**London Borough of Haringey Planning Application Reference: HGY/2023/0850
139 Cranley Gardens, Hornsey, London, N10 3AG**

We are responding to the council setting out more clearly the details of how the development will potentially obstruct an overland flood route and exacerbate street flooding at Park Road as follows:

Extract of Environment Agency Flood Risk Mapping showing Surface Water overland flood route across the property

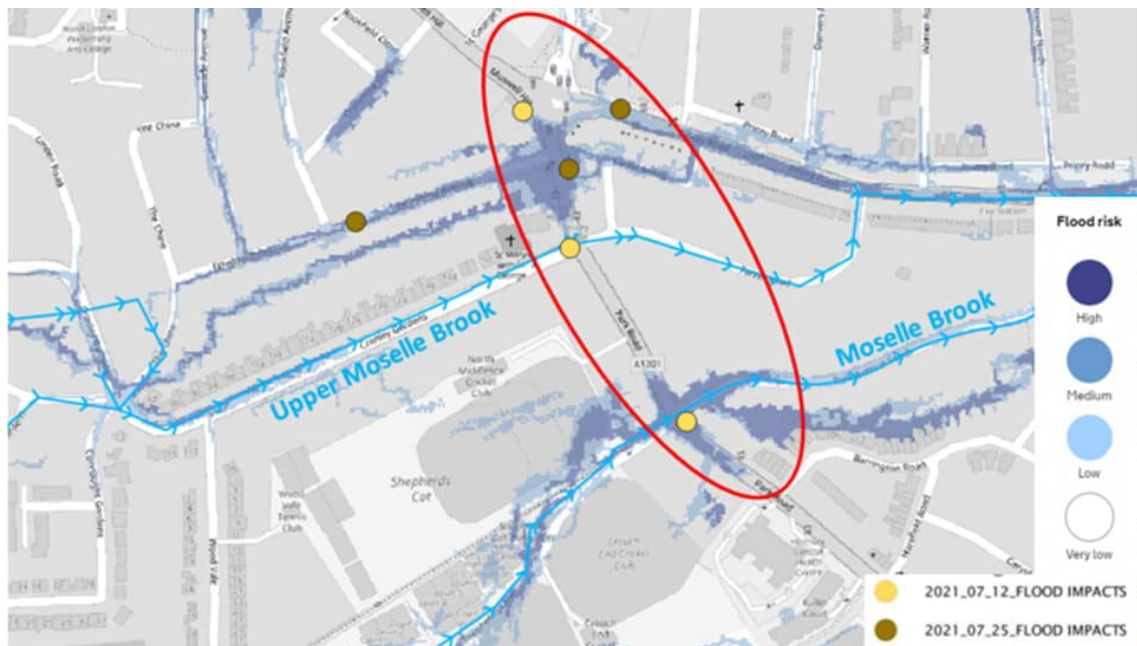
In this case the current overland flow routes that have been established by the Environment Agency are indicated to route across the property away from the Cranley Gardens carriageway and out of the

Upper Moselle catchment and down into the green area afforded by the Cricket Club, where some natural flow attenuation can be expected before the water enters the main Moselle Brook. Any interruption of that process that will simply work towards exacerbating the Park Road highways drainage /sewer flooding issue that have just had a lot of public money spent on mitigation.

Any flood flow across the property as indicated above will dissipate to some degree within the green space of the playing fields, whereas if this flow is to be diverted back onto the Cranley Gardens carriageway it will have no such opportunity and will simply add to the water that already collects at the Park Road/ Priory Road Junction.

Extract of Fig 5-3 of January 2022 Section 19 Flood Investigation report (McCloy Consulting)

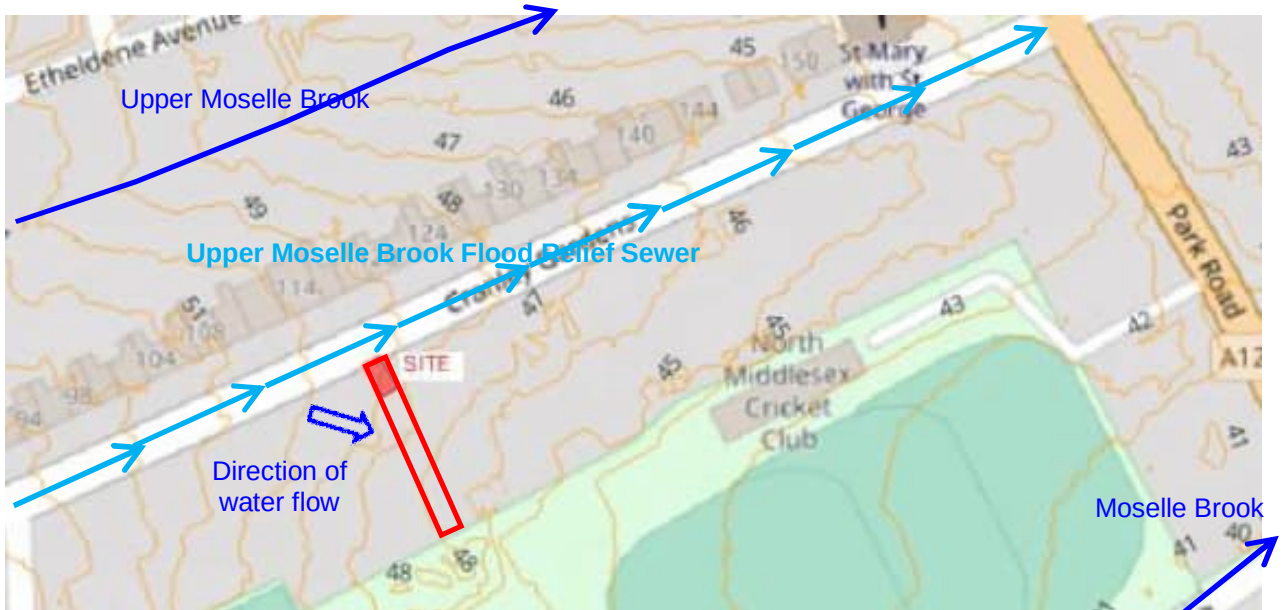
There has been a misinterpretation of a figure taken from the January 2022 Section 19 Flood Investigation Report for Park Road (North) by McCloy (reproduced below) and a suggestion that the Moselle Brook flowed along Cranley Gardens itself and had been culverted.

Annotated extract of Fig 4 of Flood Risk Assessment and SuDS report (Symmetrys)

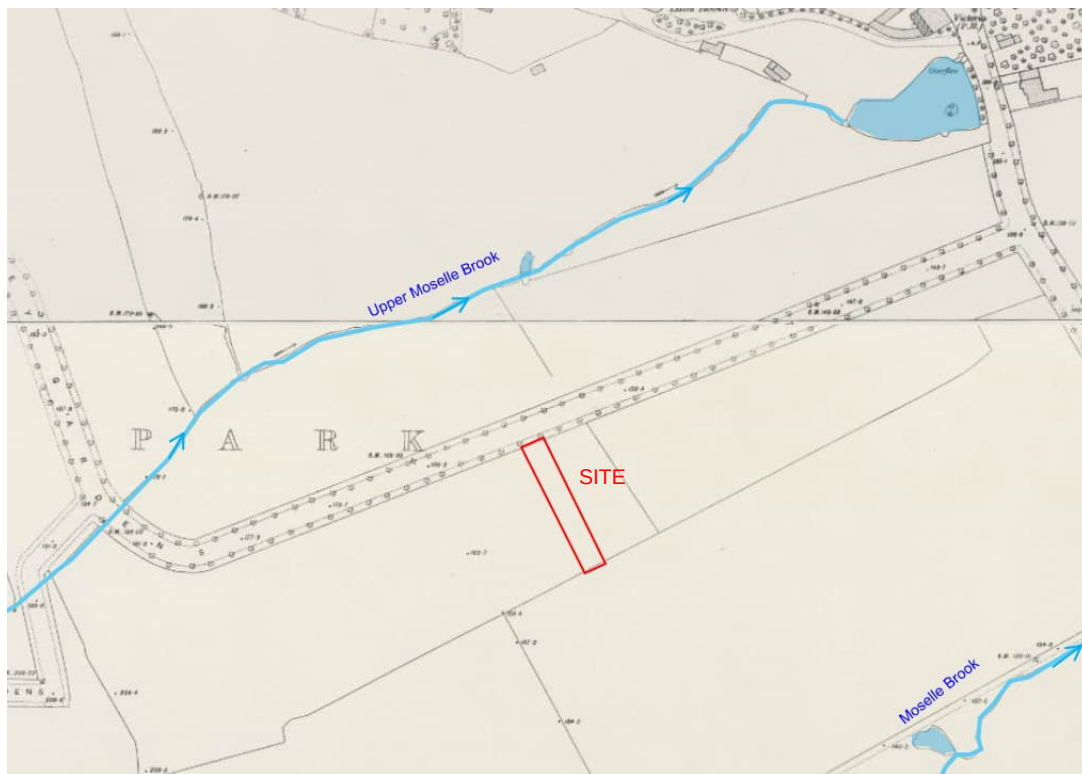
A cursory inspection of the topography of Cranley Gardens show that Cranley Gardens runs down an elevated spur that forms a watershed between two streams and it is a reflection of the quality and extent of the applicant's flood risk assessment that this has not been recognised. Instead the applicant introduces a proposal to introduce “**ground improvement across the site**” and recommends “**trial pits to be dug across the site and logged by a geotechnical engineer prior to any construction works.**” These proposals suggest a worrying lack of understanding of the site setting.
